Product Change Notice (PCN)

Subject: Transfer of back-end production for general-purpose linear IC products (SOP package products)

Publication Date: 1/19/2024

SOP-14 :

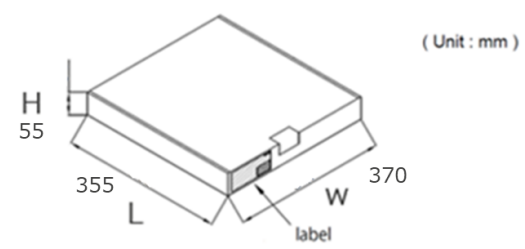
There are some dimensional differences in the outline drawing, but the recommended foot pattern remains the same.

Current products		UTL products	
(UNIT:mm)		(UNIT:mm)	
ITEM	MILLIMETERS	ITEM	DIMENSIONS
A	10.2 ±0.26	A	10.2±0.2
B	1.42 MAX	B	1.42MAX
C	1.27 (T.P)	C	1.27(T.P)
D	0.42 ^{+0.08} _{-0.07}	D	0.40±0.05
E	0.1 ±0.1	E	0.1±0.1
F	1.59 ^{+0.21} _{-0.2}	F	1.59±0.20
G	1.49	G	1.49
H	6.5 ±0.2	H	6.5±0.2
I	4.4 ±0.1	I	4.4±0.1
J	1.1 ±0.16	J	1.05±0.15
K	0.17 ^{+0.08} _{-0.07}	K	0.2±0.07
L	0.6 ±0.2	L	0.6±0.20
M	0.1	M	0.1MAX
N	0.10	N	0.1MAX
P	3° ^{+7°} _{-3°}	P	4°±4°

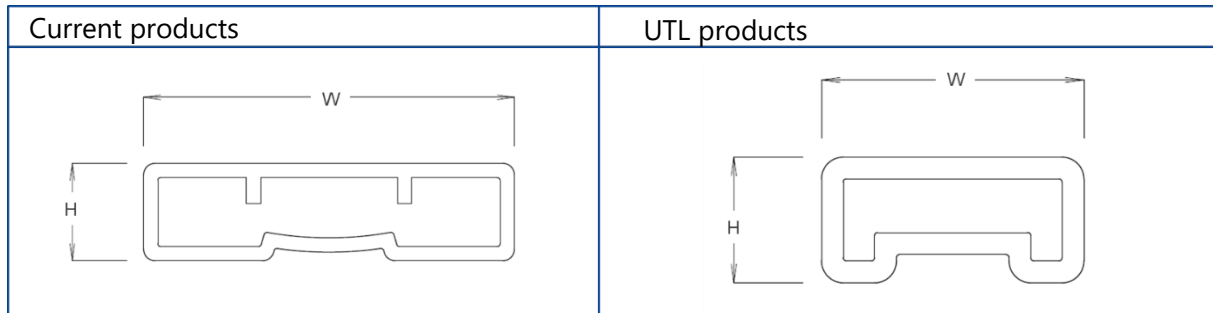
The size of the tube is different as follows.

PKG	Current products (L×W×H), Quantity	UTL products (L×W×H), Quantity
SOP-8	530×13×3.4 (mm), Max100pcs	507~509×8.4×4.0 (mm) , Max90pcs
SOP-14	530×13×3.4 (mm), Max50pcs	507~509×8.4×4.0 (mm) , Max45pcs

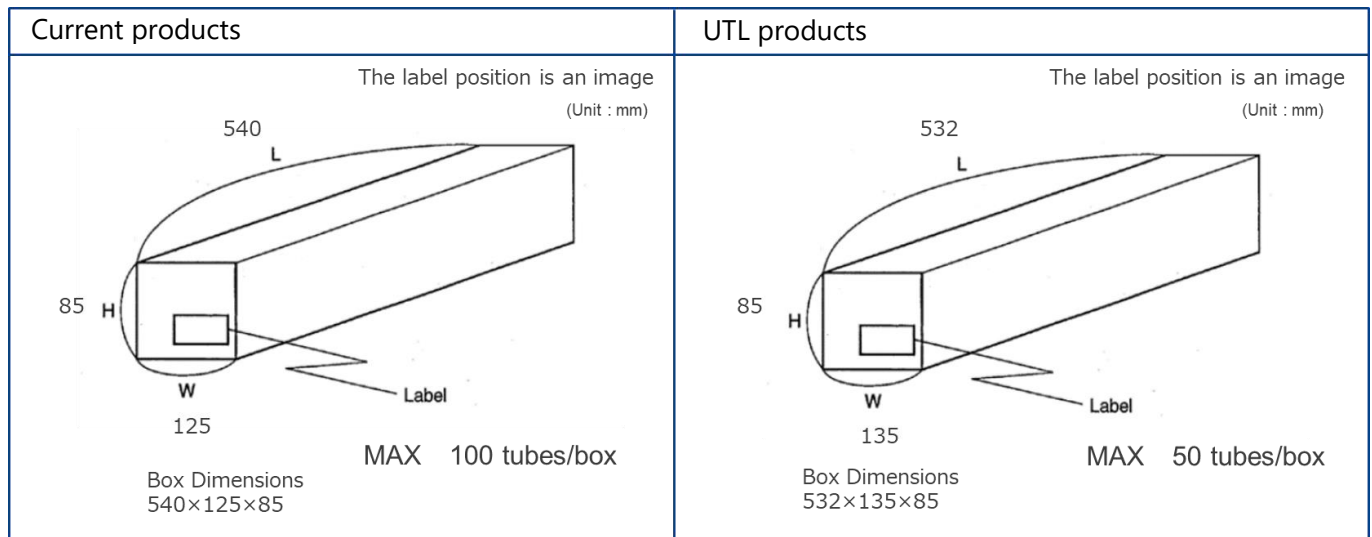
The packaging box size of the tube product is different as follows.

Current products (L×W×H)	UTL products (L×W×H)
540×125×85 (mm)	532×135×85 (mm)
